DEPARTMENT OF TRANSPORTATION

RE: Preliminary Plan No. 11985027B
Montgomery Auto Park Lot 17 & 18
Preliminary Plan Letter-**REVISED**

Re: **REVISED COMBINED STORMWATER
MANAGEMENT CONCEPT/SITE
DEVELOPMENT STORMWATER
MANAGEMENT PLAN** for
Montgomery Auto Sales Park Lot 18 Revision
Preliminary Plan #: 11985027A
SM File #: 264015
Tract Size/Zone: GR-1.5 / H-85
Total Concept Area: 4.1 ac
Lots/Block: Lots 17 & 18
Parcel(s): N832
Watershed: Little Paint Branch
Redevelopment (Yes/No): Yes

82014014A Montgomery Auto Sales Park Lot 18

At Entrance #1 Looking Right

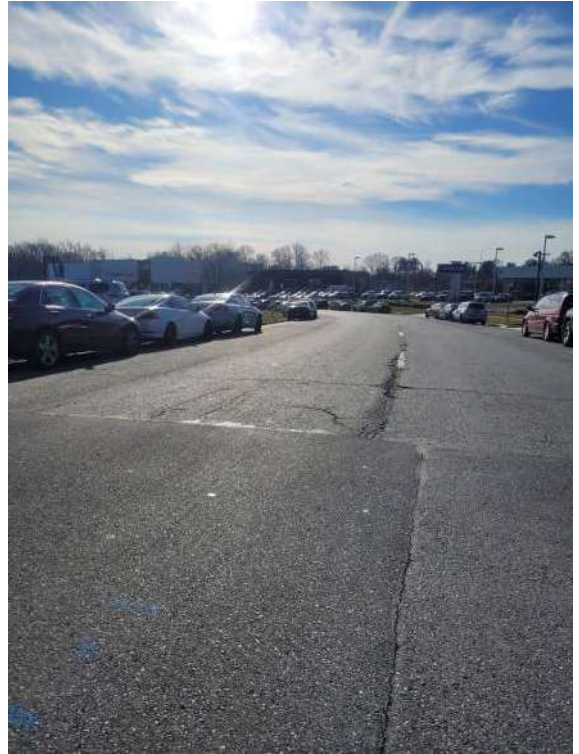
Driveway #1			
CLASS	Industrial Street		
SPEED (MPH)	25		
APPROACHING MOTOR VEHICLES			
VERTICAL	TARGET (FT)	MEASURED (FT)	OK?
	L	NA - One way Street	
	R	3.5	3.5
HORIZONTAL APPROACHING MOTOR VEHICLES			
	Grade	TARGET (FT)	MEASURED (FT) OK?
L	NA - One way Street		
R	4.7%	240	400 OK
HORIZONTAL APPROACHING BIKEWAYS			
	Grade	TARGET (FT)	MEASURED (FT) OK?
L			NA
R			NA
HORIZONTAL APPROACHING SIDEWALK (IF DIRECTED)			
	Grade	TARGET (FT)	MEASURED (FT) OK?
L			Not Measured
R			Not Measured
COMMENTS			
No parking signs required 145' right of the proposed entrance per the included exhibit to achieve minimum sight distance with parked vehicles. Sight distance of 400' based on no parked vehicles.

Approved (See Preliminary Plan Comments-Condition#6)

At Entrance #2 Looking Right

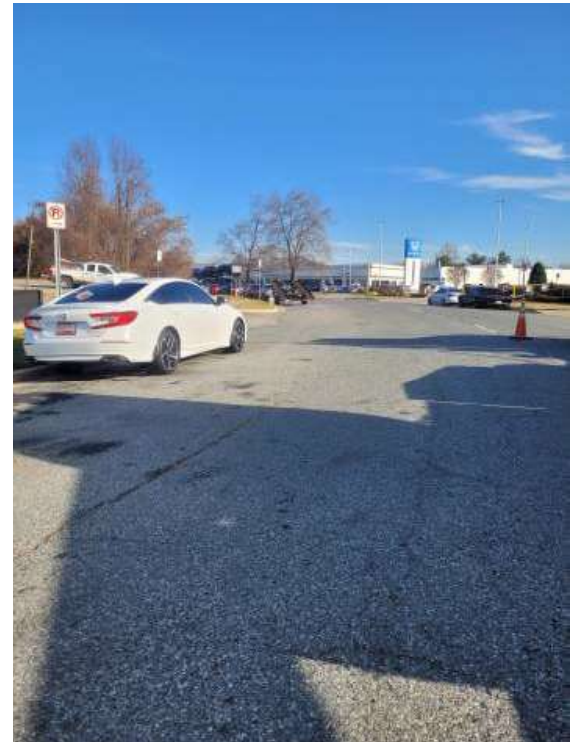
Driveway #2			
CLASS	Industrial Street		
SPEED (MPH)	25		
APPROACHING MOTOR VEHICLES			
VERTICAL	TARGET (FT)	MEASURED (FT)	OK?
	L	NA - One way Street	
	R	3.5	3.5
HORIZONTAL APPROACHING MOTOR VEHICLES			
	Grade	TARGET (FT)	MEASURED (FT) OK?
L	NA - One way Street		
R	0.9%	240	300 OK
HORIZONTAL APPROACHING BIKEWAYS			
	Grade	TARGET (FT)	MEASURED (FT) OK?
L			NA
R			NA
HORIZONTAL APPROACHING SIDEWALK (IF DIRECTED)			
	Grade	TARGET (FT)	MEASURED (FT) OK?
L			Not Measured
R			Not Measured
COMMENTS			
No parking signs required 183' right of the proposed entrance per the included exhibit to achieve minimum sight distance with parked vehicles. Sight distance of 300' based on no parked vehicles.

Approved (See Preliminary Plan Comments-Condition#6)
